From: David Cory Frankel [davidcoryfrankel@gmail.com]
Sent: Friday, November 07, 2008 9:24 PM
To: NRCREP Resource
Cc: Shannon Anderson
Subject: Re: GEIS - Comments - Crow Butte Resources - Abitz Opinion Part 2 of 3
Attachments: Abitz Opinion - CBR summary-28july2008 part 2 of 3.pdf

Federal Register Notice: 73FR43795
Comment Number: 1306

Figure 4. Proper use of a control chart to determine lixiviant excursions.

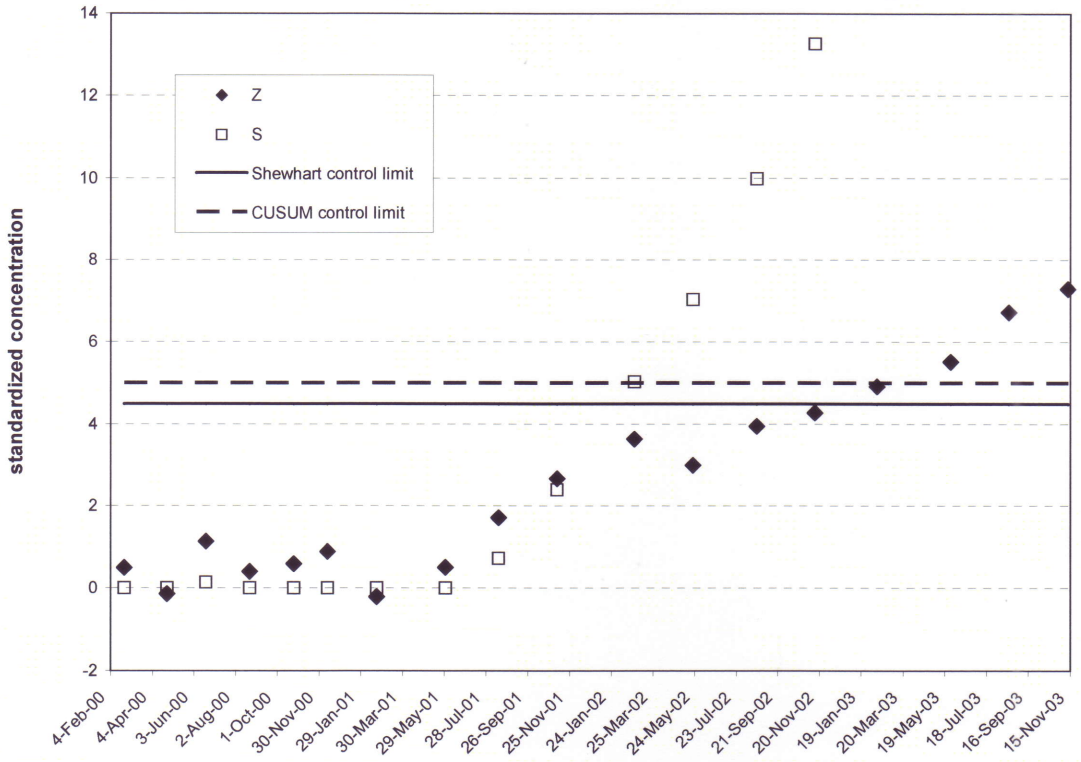
Figure 4 illustrates the importance of using the SCL and CUSUM for monitoring lixiviant excursion. The SCL (Z) and CUSUM (C) are plotted for an excursion parameter, a gradual increase in contamination exceeds the CUSUM limit in February of 2002, while the SCL limit is not exceeded until January of 2003. The SCL limit is similar to the CBR's use of 5 standard deviations above the mean for any one sampling event, although EPA recommends 4.5 standard deviations for any one sampling event. Using only the SCL limit allows contamination to migrate beyond the monitoring well for nearly a year before an excursion is declared. Therefore, if the CUSUM is not used with the SCL limit a gradual increase in contamination will not be detected and migration of diluted lixiviant will pass the montoring well without corrective action.
